Well Name: JAMES RANCH UNIT DI 7 SAWTOOTH	Well Location: T23S / R31E / SEC 6 / LOT 3 /	County or Parish/State:
Well Number: 906H	Type of Well: CONVENTIONAL GAS WELL	Allottee or Tribe Name:
Lease Number: NMNM02953C	Unit or CA Name: JAMES RANCH	Unit or CA Number: NMNM070965Z
US Well Number:	Well Status: Approved Application for Permit to Drill	Operator: XTO PERMIAN OPERATING LLC

Sundry ID: 2774012

Type of Action: APD Change

OPERATOR'S NAME:	XTO Permian Operating LLC
WELL NAME & NO.:	James Ranch Unit DI 7 Sawtooth 906H
LOCATION:	Sec 06-23S-31E-NMP
COUNTY:	Eddy County, New Mexico

WELL LOCATION AND ACREAGE DEDICATION PLAT

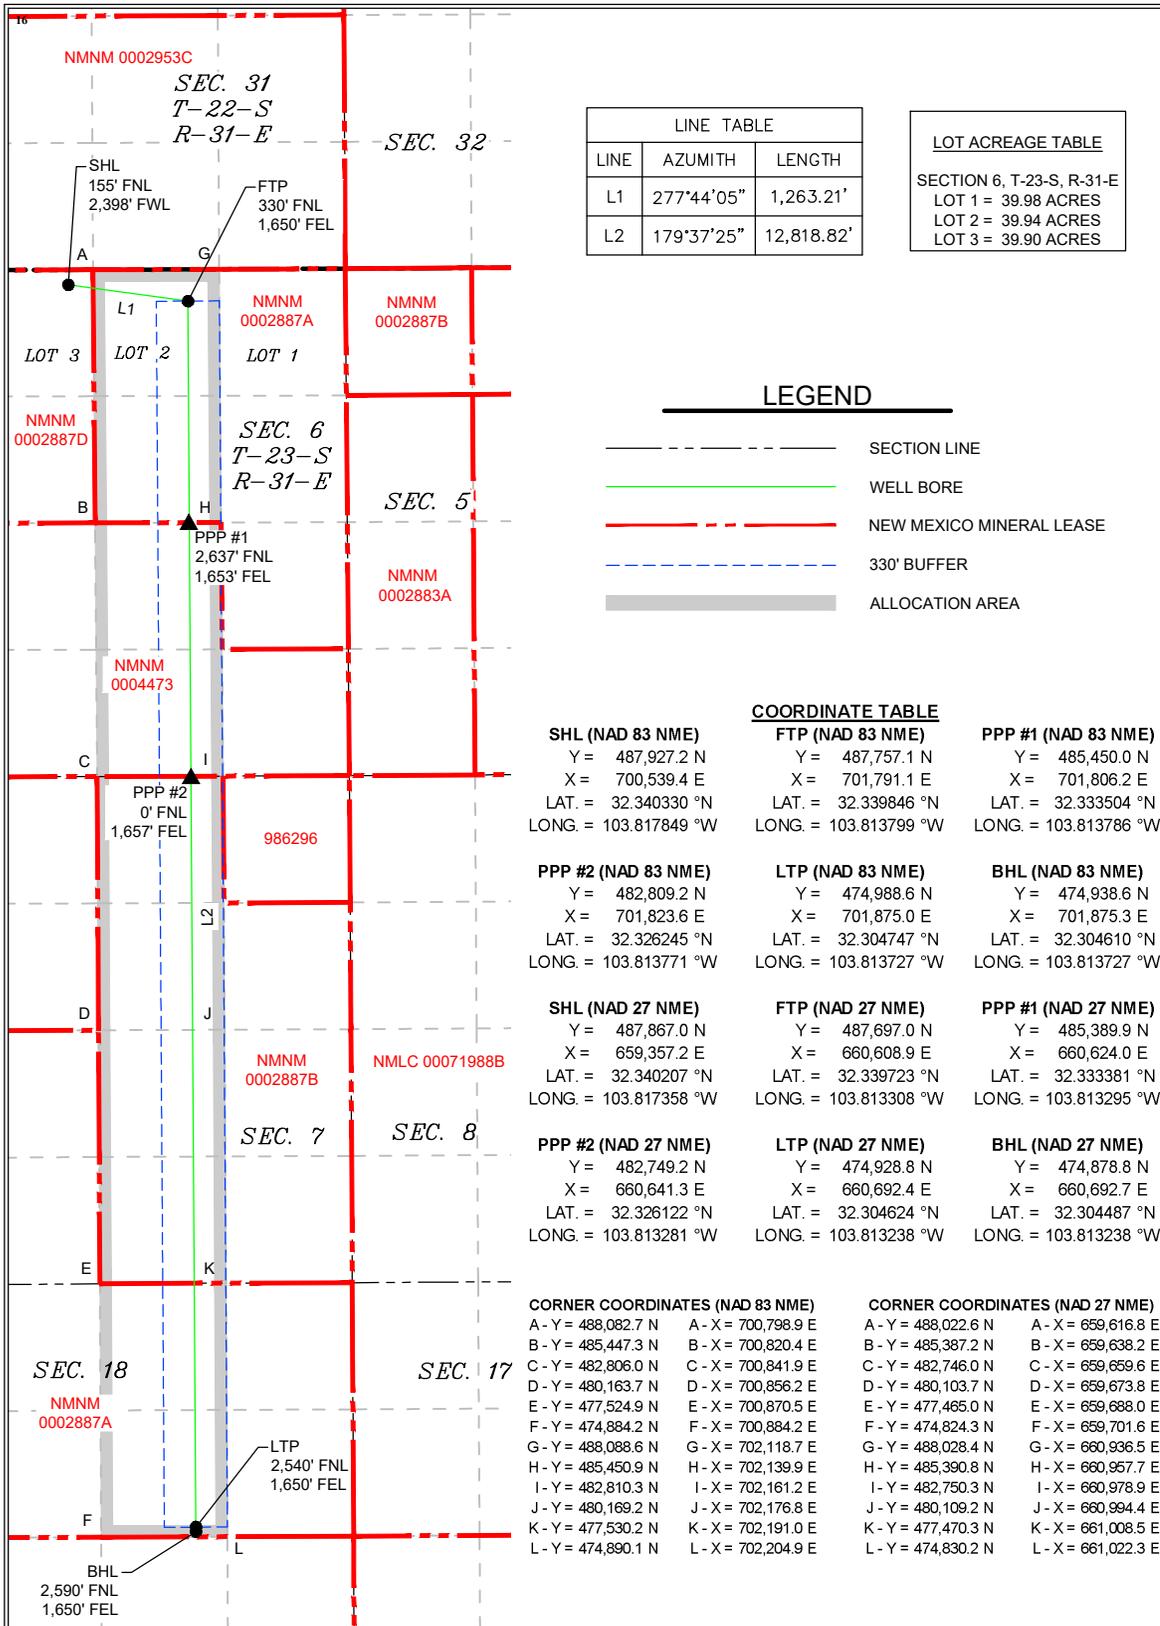
XTO Permian Operating LLC respectfully requests a change to the wellbore location that will include the following changes: Surface Hole Change, First and Last Take Point, Bottom Hole, proposed total depth and formation (pool).

SHL: F/ 155 FNL & 2458 FWL TO: 155 FNL & 2398 FWL of Section 6-T23S-R31E

FTP: F/ 700 FSL & 1870 FEL TO: 330 FNL & 1650 FEL of Section 6-T23S-R31E

PPP1: F/ 2637 FNL & 1873 FEL PPP1: 2637 FNL & 1653 FEL

PPP2: F/ 0 FSL & 1876 FEL PPP2: 0 FNL & 1657 FEL

LTP: F/ 2540 FNL & 1870 FEL TO: 2540 FNL & 1650 FEL of Section 18-T23S-R31E

BHL: F/ 2590 FNL & 1870 FEL TO: 2590 FNL & 1650 FEL of Section 18-T23S-R31E

Proposed TD: F/ 25,389' MD; 11,160' TVD (Los Medanos (Wolfcamp) South) TO: 23,679' MD; 11,001' TVD (Los Medanos; Bone Spring)
